**THE
NATIONAL
BOARD**
OF BOILER AND
PRESSURE VESSEL
INSPECTORS

SUBCOMMITTEE REPAIRS and ALTERATIONS

AGENDA

*Meeting of January 20, 2010
Austin, Texas*

FIGURE S1.2.9.4-a
Locomotive Firebox Thermic Siphon Installation

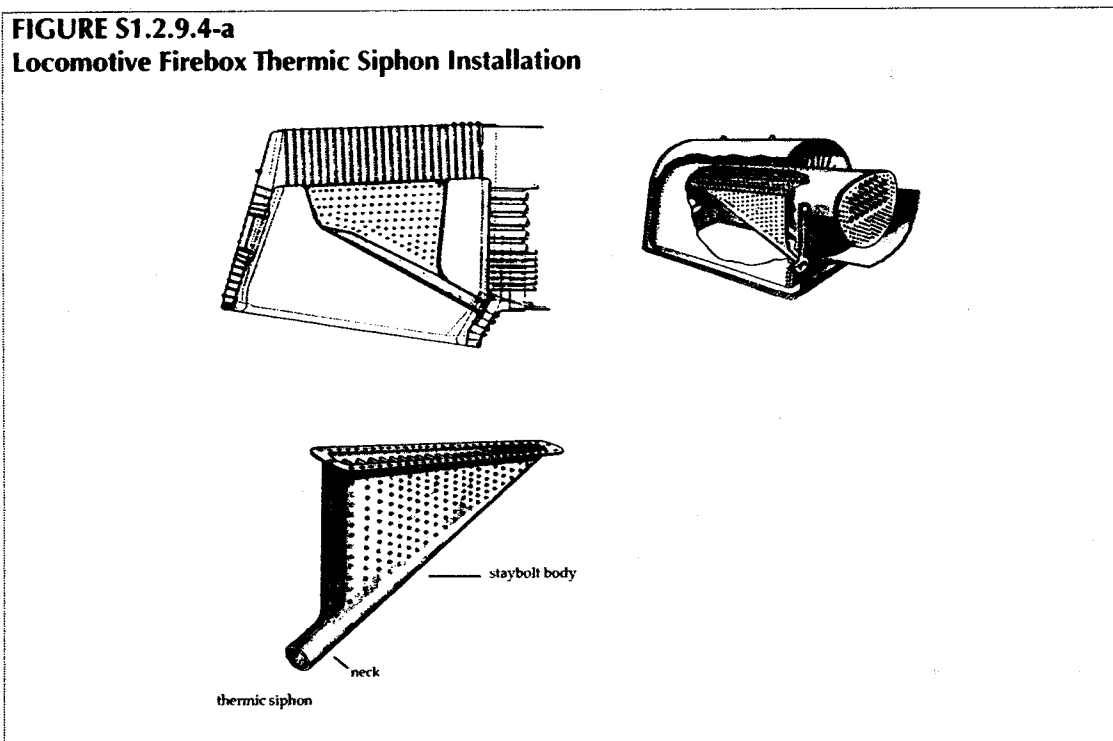
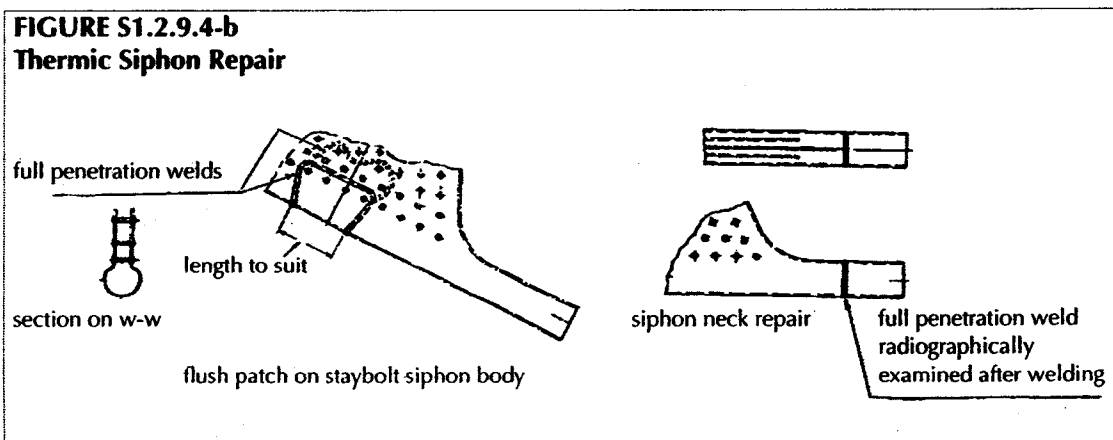
NB10-0102 Part 3 S1.2.10 SG on Locomotives Clarify requirements for repairs and alterations to Boiler Barrel unstayed areas. (Attachment 3, pgs 5-7)

A07 FIGURE S2.13.9.2 Unstayed Area Crack Repair

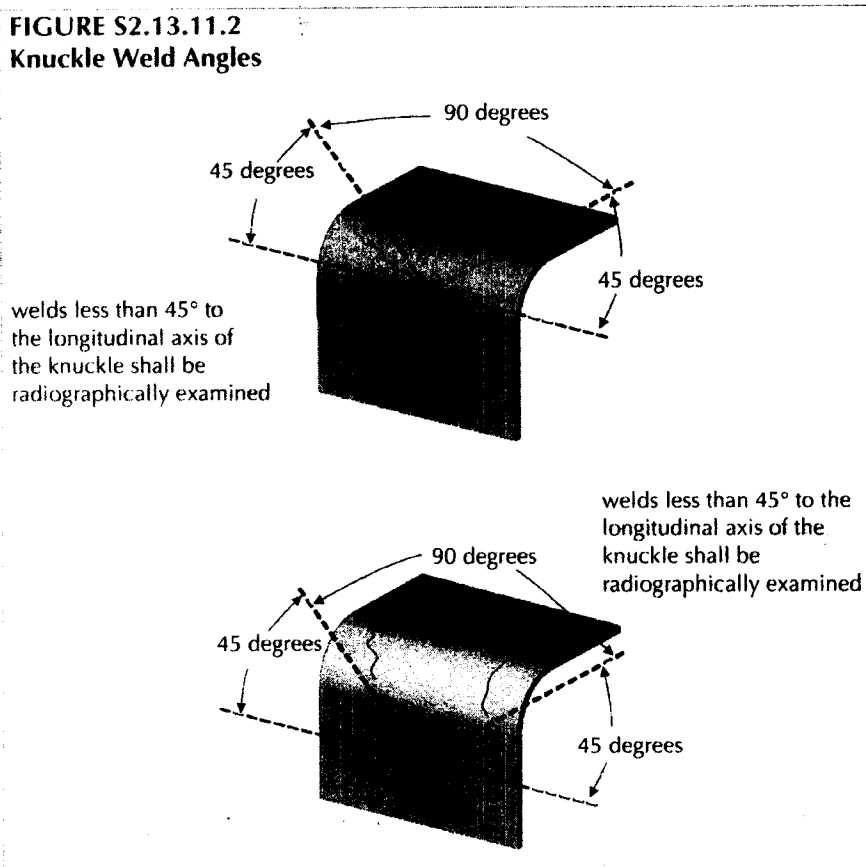
NB10-0103 Part 3 Part 3 S2.13.9.2 SG on Historical Resolve conflict of text and figure. S2.13.9.2. (Attachment 3, pg. 8)

A07 FIGURE S2.13.12.3 Tubesheet Flush Patch

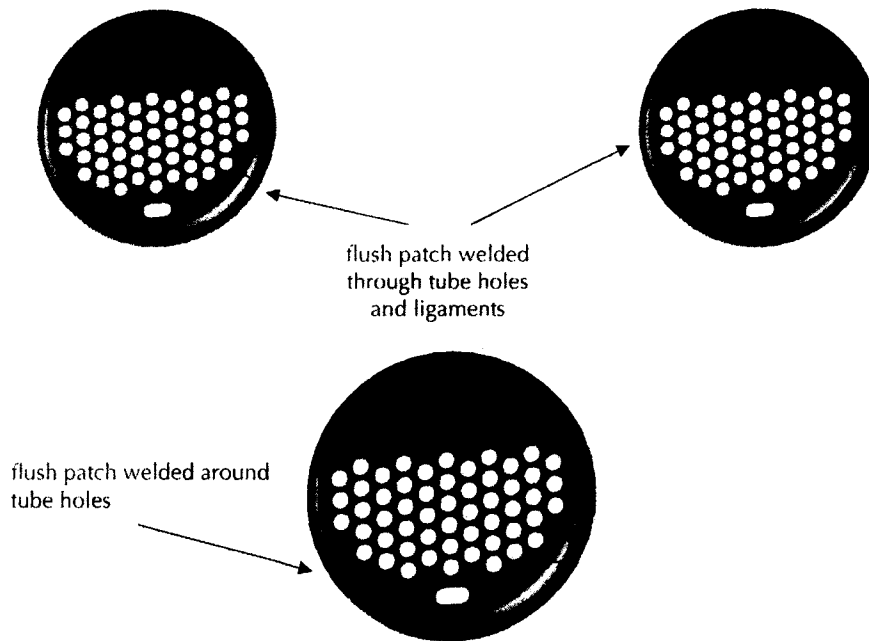
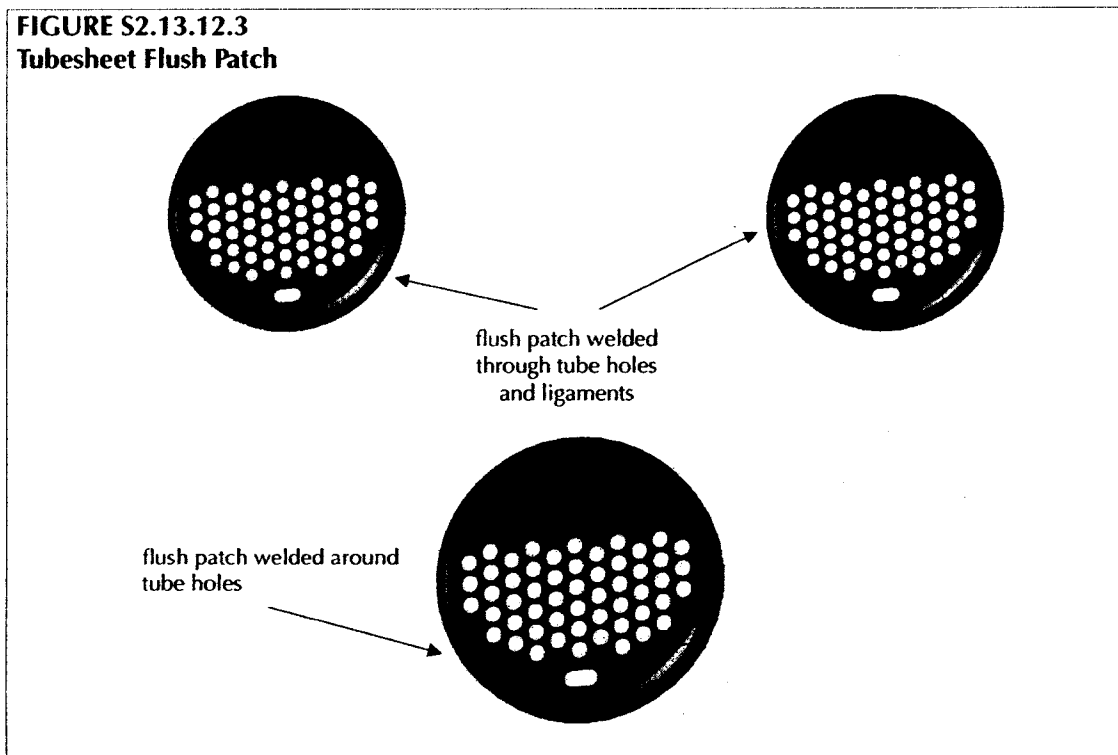
NB10-0104 Part 3 S2.13.12.3 SG on Historical Should the reference in a) be to S2.13.11.2 or what is written. (Attachment 3, pgs. 9-11)

FIGURE S2.13.12.2
Stayed Area Crack Repair

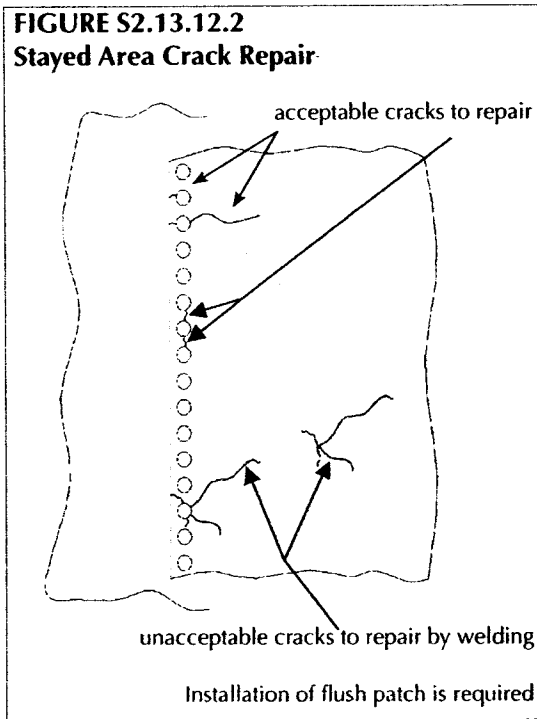
NB10-0105 Part 3 S2.13.12.2 SG on Historical Remove a) from paragraph and revise wording so both paragraphs are clear. Clarify rules for Welded Flush Patches in Tubesheets. (Attachment 3, pgs. 12-13)
